Project: 1078 Harbour Island Road – accessory building construction
Date: December 17, 2021

This review is for an application to construct an additional building (accessory structure) on the existing single family lot at the above address. The property is within the Harbour Island Subdivision 1, Lot 23.

The applicant proposes to construct an accessory structure on the same lot. The structure includes approximately 1,724 SF of new impervious area to the lot. The structure is not shown to be directly connected to the existing home.

SHEET TITLE:
NEW SITE PLAN

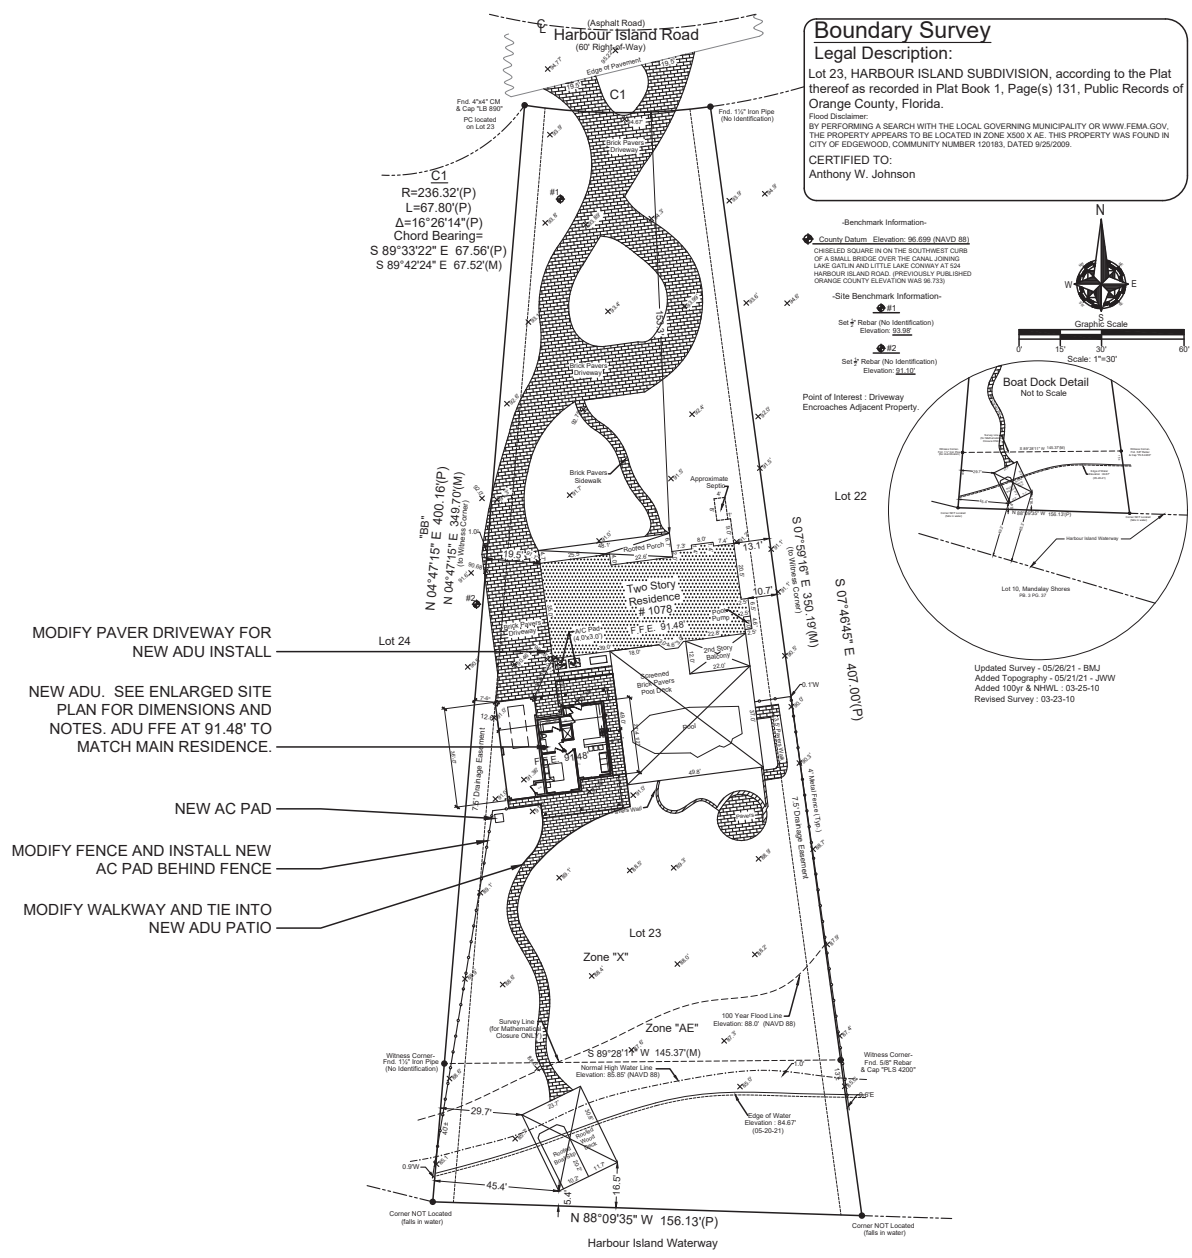
The proposed accessory structure is greater than the minimum 5 foot setback, per Section 134-483. The proposed distance is 7'-6", which is outside the existing side yard drainage easement.

Section 134-483, (i) - The maximum height may not exceed the height of the principal structure. The height is shown on the site plan as 14'-6", which is less than the height of the home and less than the maximum of 16' for accessory structures.

The plans also proposed a 36' by 11'-8" carport. The total area of the car port is 420 SF. Per Section 134-483, (g) – detached garages shall be limited to a maximum of 600 SF.

The existing impervious area for the lot is 10,912 SF. The new total impervious area with the new addition and the changes to the driveway is approximately 12,636 SF. The total lot area is 54,908 SF. The percent impervious after construction will be approximately 23%, which is below the allowable limit of 45%.
